# Road Safety Audit Response Report

<b>Report title:</b>	Lye Lane, Bricket Wood, Stage 1 RSA Response
<b>Date:</b>	27/09/22
<b>Document reference and revision:</b>	P2584 Stage 1 RSA Response v1
<b>Prepared by:</b>	Paul Mew Associates
<b>On behalf of:</b>	MRP Planning / JD Rudkin (Builders) Ltd

**Proposed S278 Highway Works**

**Stage 1 Road Safety Audit**

P2584: Land North of Bricket Wood, Herts  
 Refuse Vehicle Entering / Exiting Site

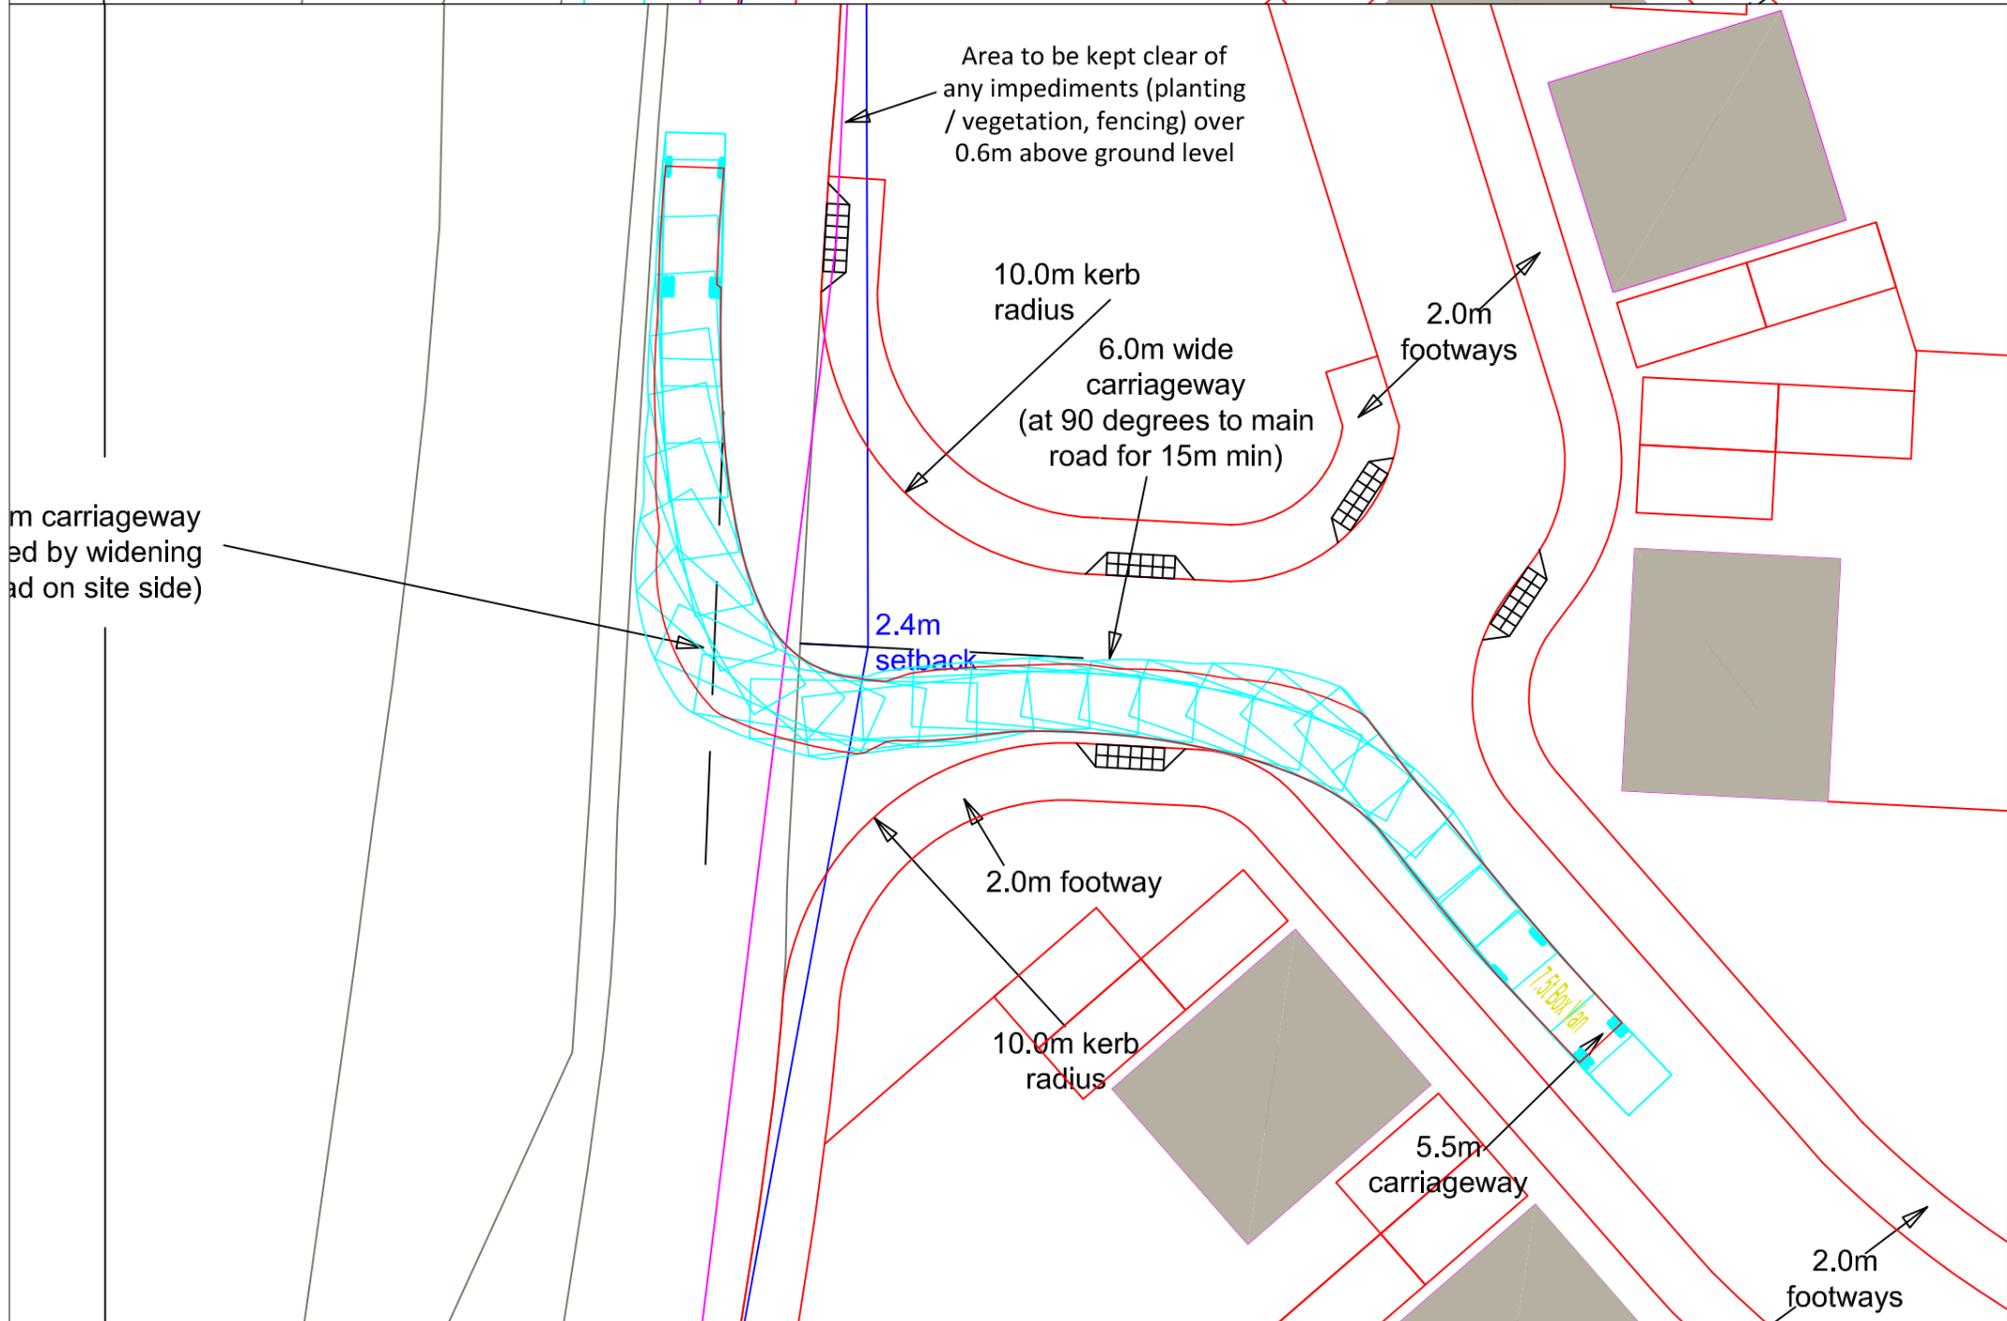
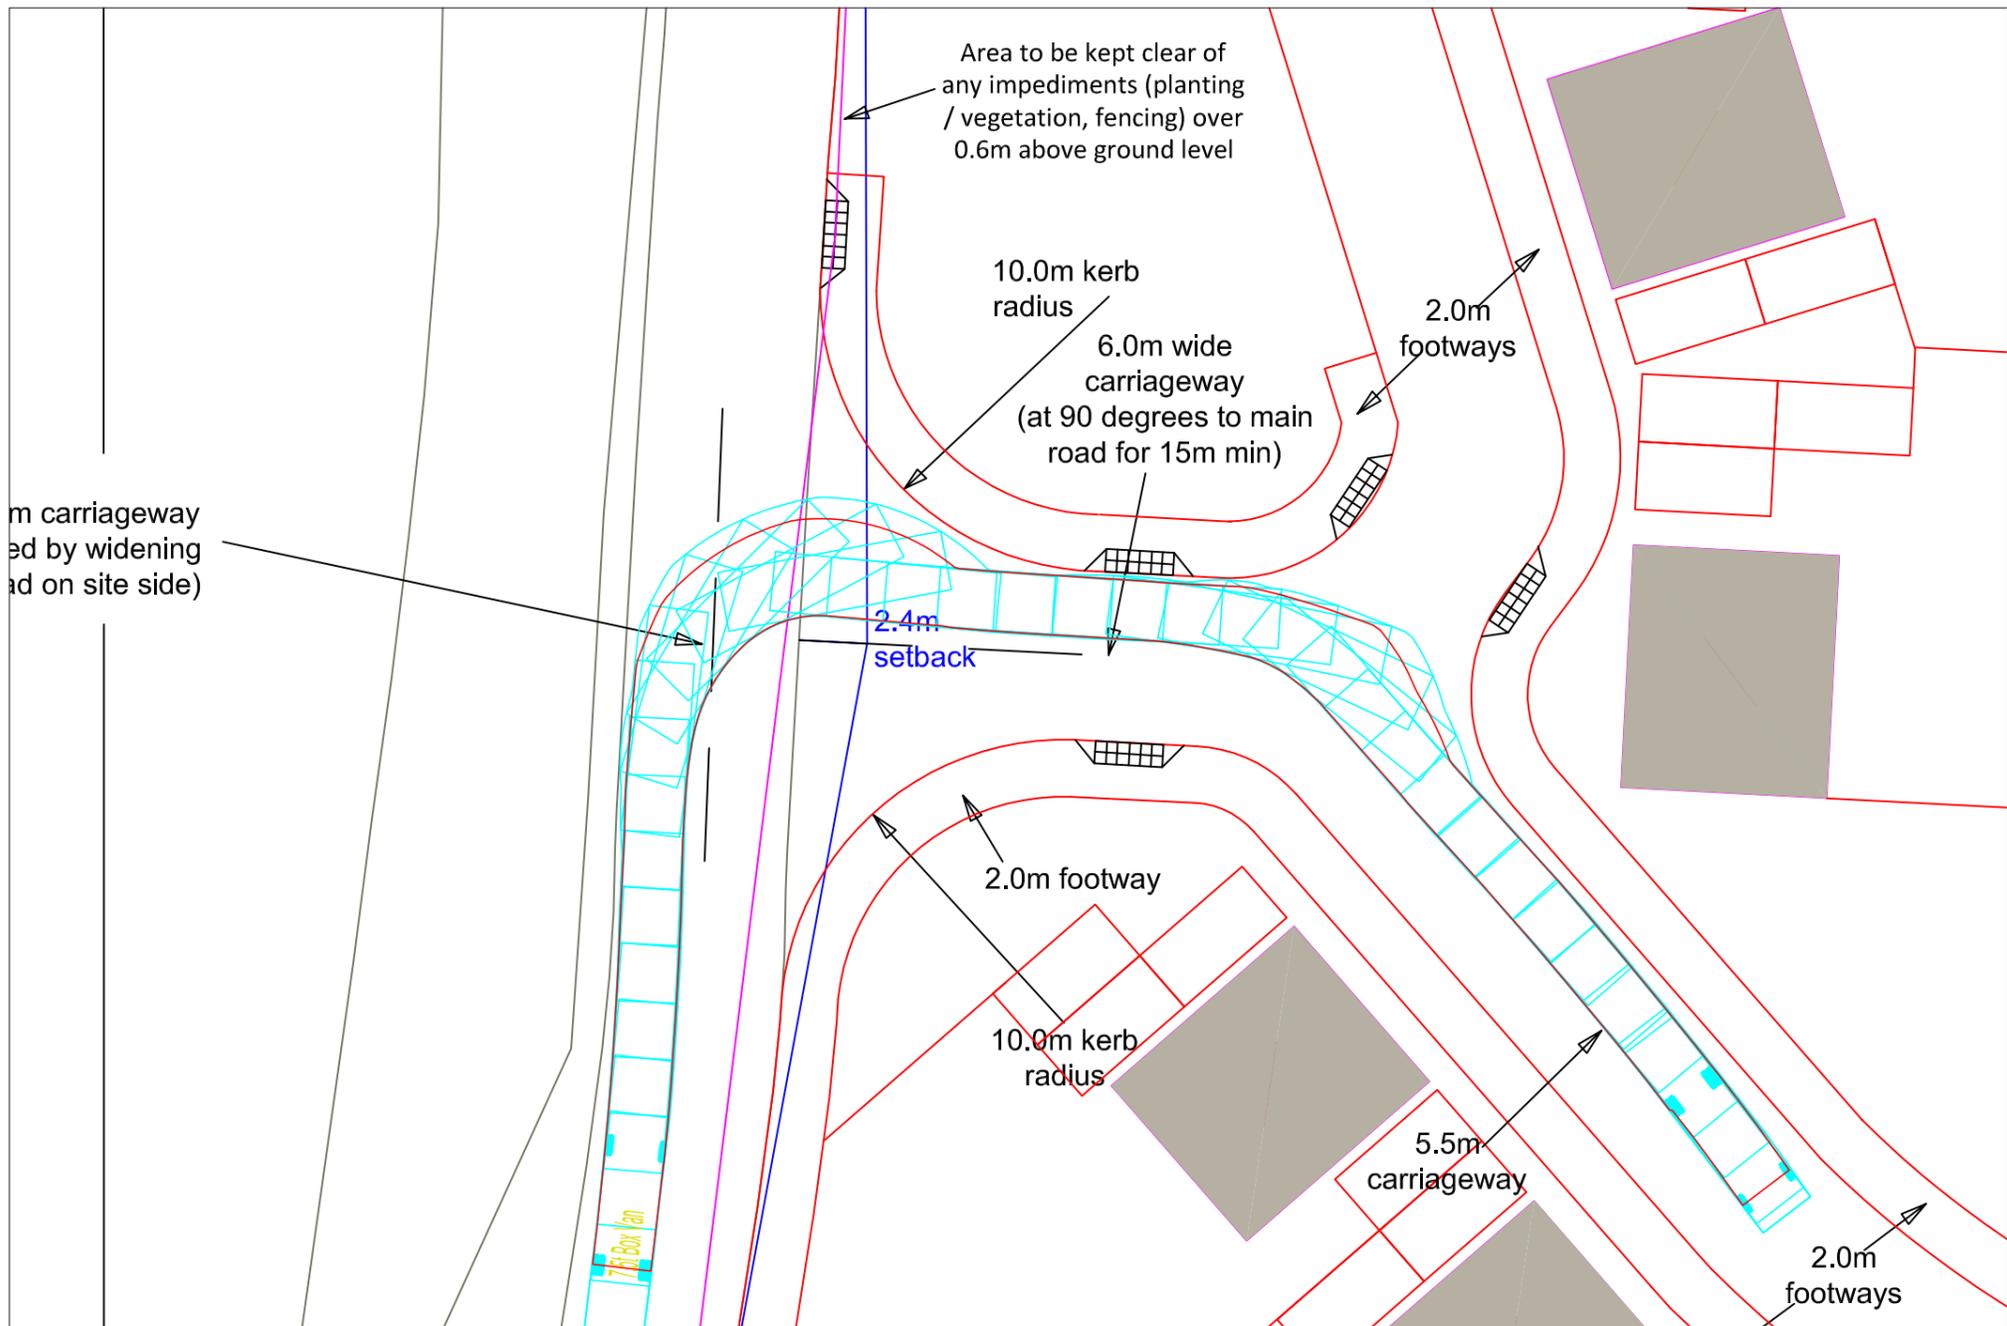
The scheme drawing indicates the swept path requirements of a Refuse Vehicle accessing and egressing the proposed development site access junction on the eastern side of Lye Lane.

It is evident from the scheme drawing that the Refuse Vehicle encroaches the centre lines within the proposed development site access junction and main carriageway of Lye Lane.

It is recommended that the junction geometry should be modified in order to mitigate the above described potential collision scenario.

Additionally, it is recommended that swept path analysis exercises of other large vehicles (i.e. Supermarket delivery and long wheel base panel vans) should be undertaken, in order to assist with the development site junction geometry requirements.

<p>Location: B – Lye Lane, development site access junction.            Summary: Swept path requirements of larger vehicles negotiating the proposed development site access junction</p>	<p>It is recommended that the junction geometry should be modified in</p>	<p>Junction geometry has been amended and swept path analysis for the refuse vehicle and other large vehicle carried out. Revised drawings are shown in Appendix B.</p>

P2584: Land North of Bricket Wood, Herts  
Proposed Uncontrolled Pedestrian Crossing Points with Dropped Kerbs / Tactile Paving  
(Indicated by Blue Arrows)

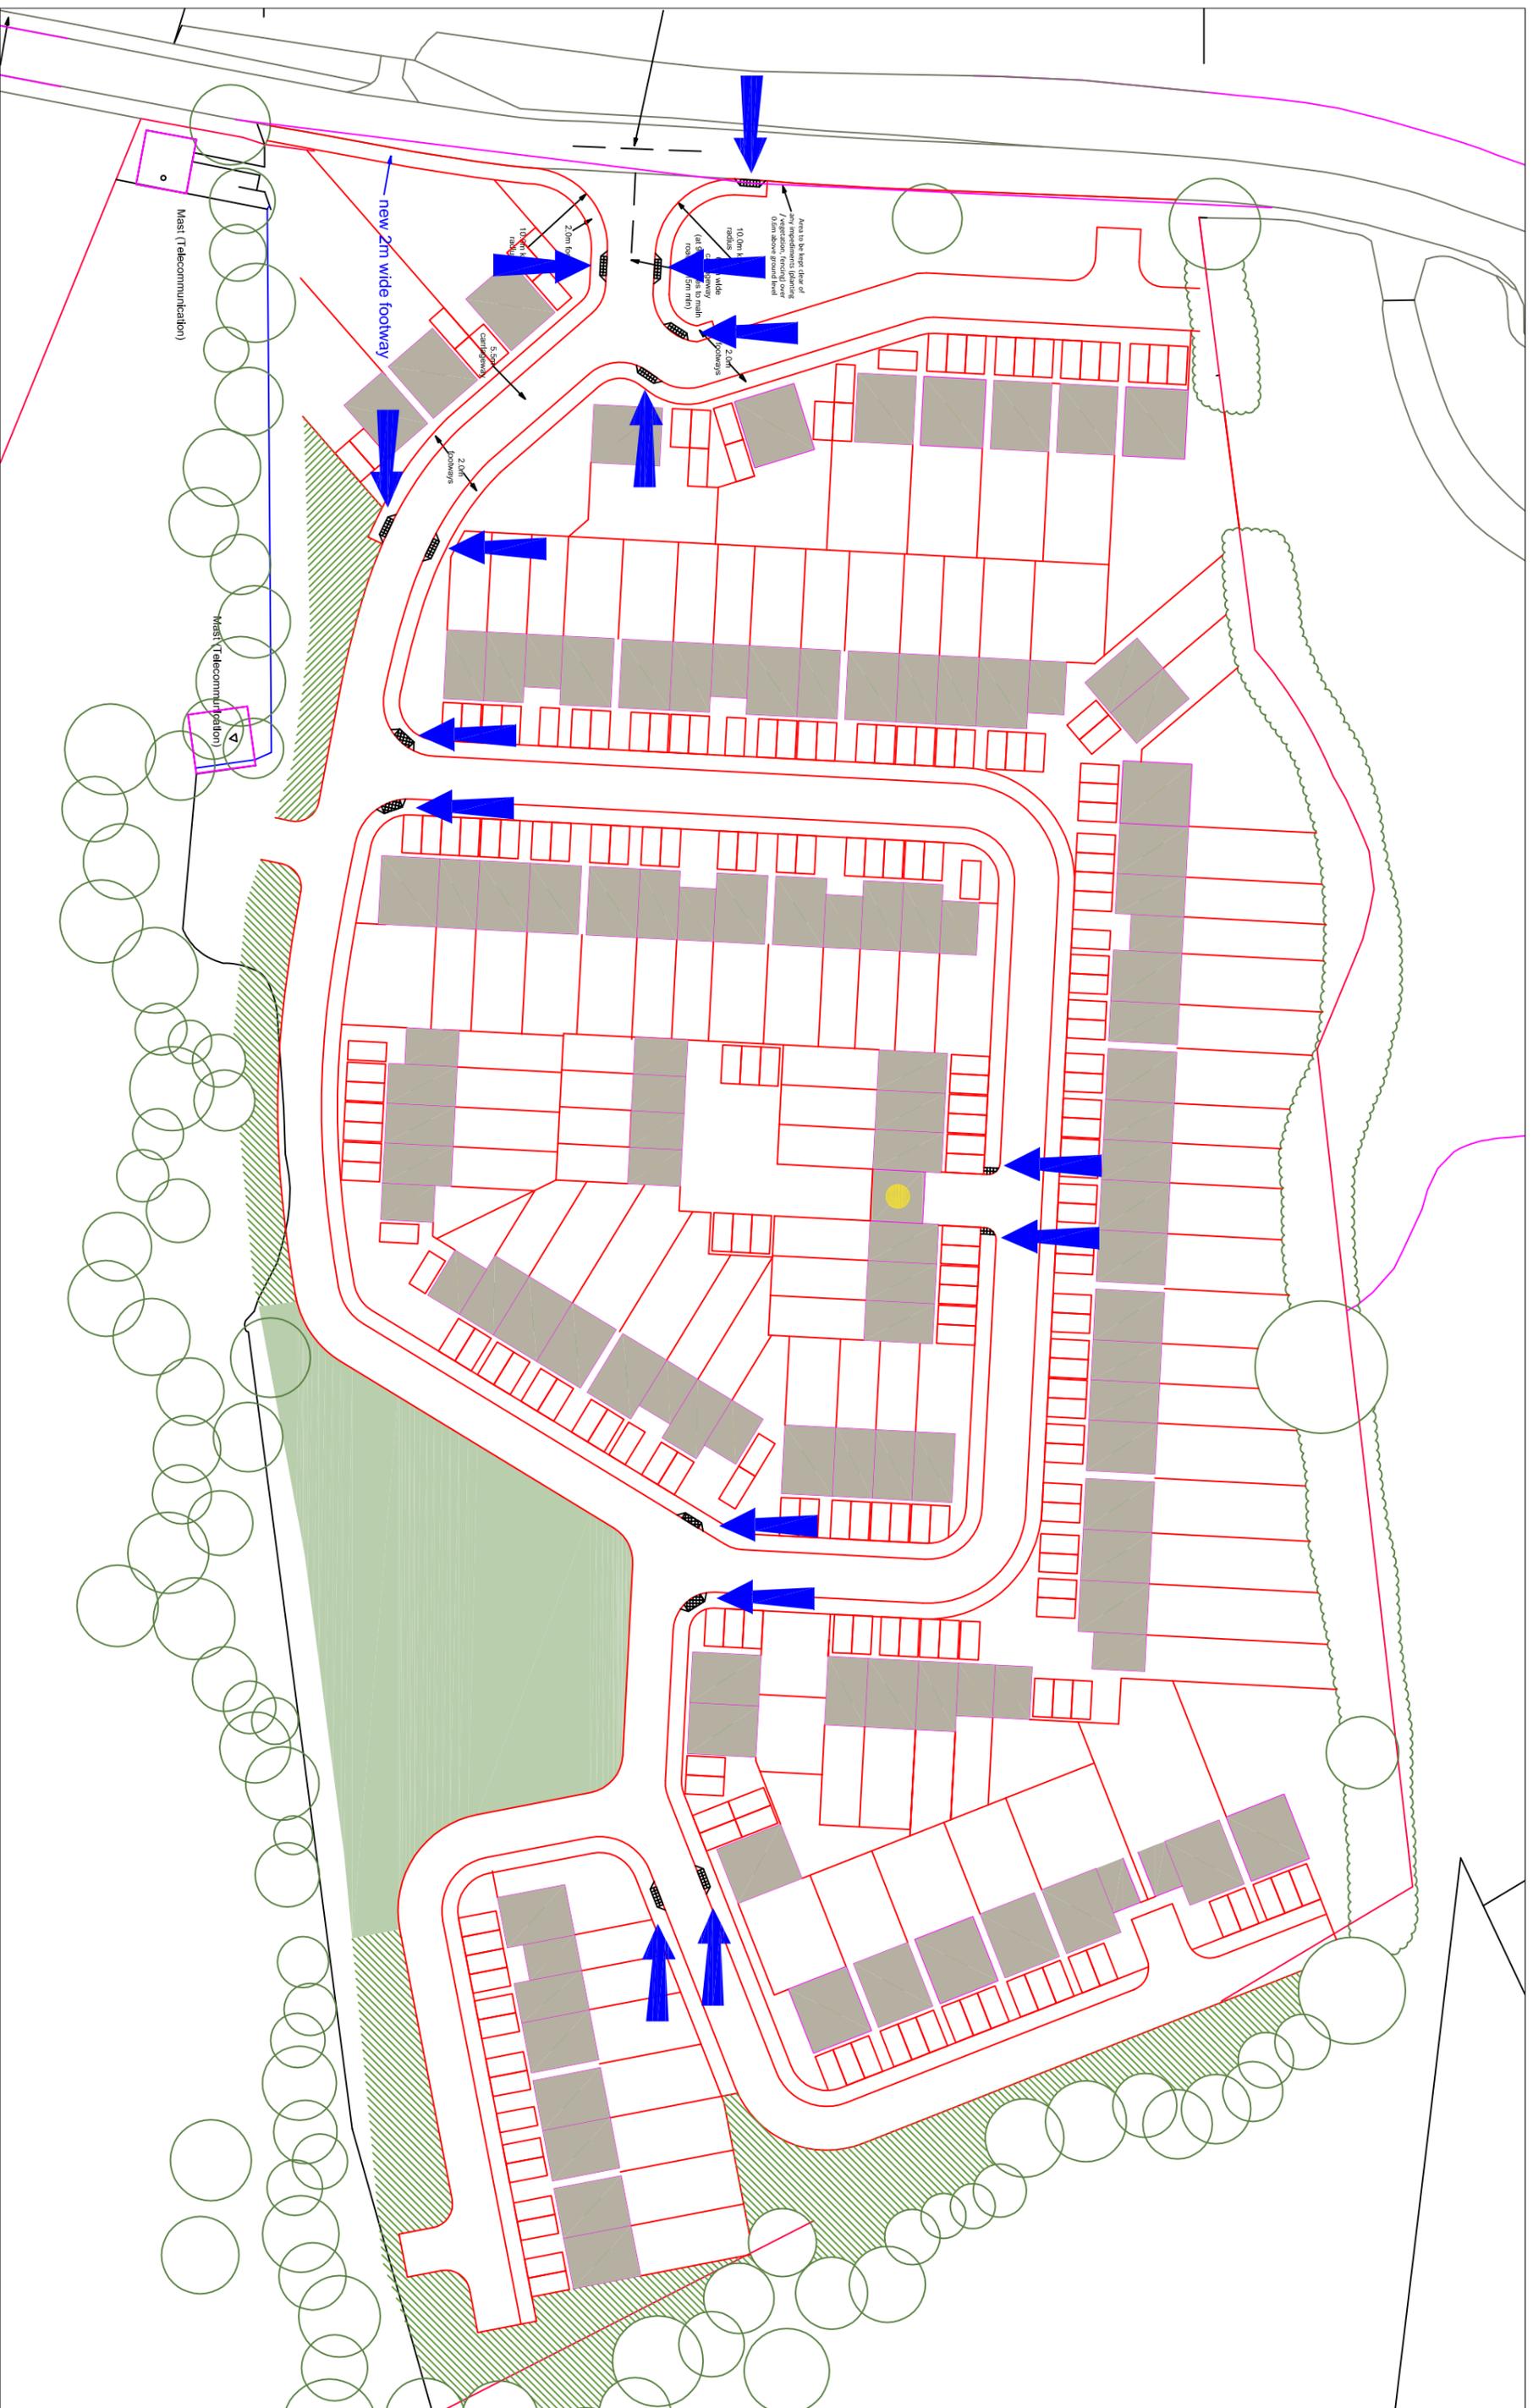
It is recommended that dropped kerbs and tactile paving should be provided across the development site access junction, in order to mitigate the above described potential injury scenario.

Additionally, it is recommended that uncontrolled pedestrian crossing facilities should be provided within the proposed development site where the footways end, in order to mitigate the above described potential injury scenario.

It is recommended that a length of dropped kerbs should be provided at this location, in order to mitigate the above described potential injury scenario.

<p>Locations: C, D and E – Development site access junction.</p> <p>Summary: Lack of dropped kerbs could result in a potential increased risk of pedestrian trips and falls occurring on the assumed full height kerb upstands, whereby pedestrians could sustain personal injury, especially those who are blind, visually or mobility impaired.</p> <p>The scheme drawing indicates the provision of a new access junction on the eastern side of Lye Lane. The scheme drawing also indicates the provision of footways leading from the proposed development site onto the new footway provision on the eastern side of Lye Lane.</p> <p>Within the proposed development site, the scheme drawing indicates that the proposed footways either side of the development site access road end, resulting in pedestrians either crossing to the opposite footway or</p>	<p>It is recommended that dropped kerbs and tactile paving should be provided across the development site access junction, in order to mitigate the above described potential injury scenario.</p> <p>Additionally, it is recommended that uncontrolled pedestrian crossing facilities should be provided within the proposed development</p>	<p>Dropped kerbs / tactile paving / uncontrolled pedestrian crossing facilities have been introduced at various locations within the proposed development site. Revised drawings are shown in Appendix B</p>

<p>Location: F – Footway to the north of the development site access junction.</p> <p>Summary: Lack of dropped kerbs could result in a potential increased risk of pedestrian trips and falls occurring on the assumed full height kerb upstands, whereby pedestrians could sustain personal injury, especially those who are blind, visually or mobility impaired.</p> <p>The scheme drawing indicates the provision of a new access junction on the eastern side of Lye Lane. The scheme drawing also indicates the provision of footways leading from the proposed development site onto the new footway provision on the eastern side of Lye Lane.</p> <p>Concern arises that pedestrians negotiating the assumed full height kerb upstands when transitioning between the footway and carriageway to the north of the proposed development site access junction, could lead to a potential increased risk of pedestrian trips and falls occurring, whereby pedestrians could sustain personal injury, especially those who may be blind, visually or mobility impaired.</p>	<p>It is recommended that a length of dropped kerbs should be provided at this location, in order to mitigate the above described potential injury scenario.</p>	<p>A dropped kerb with tactile paving will be provided at this location. Revised drawings are shown in Appendix B</p>
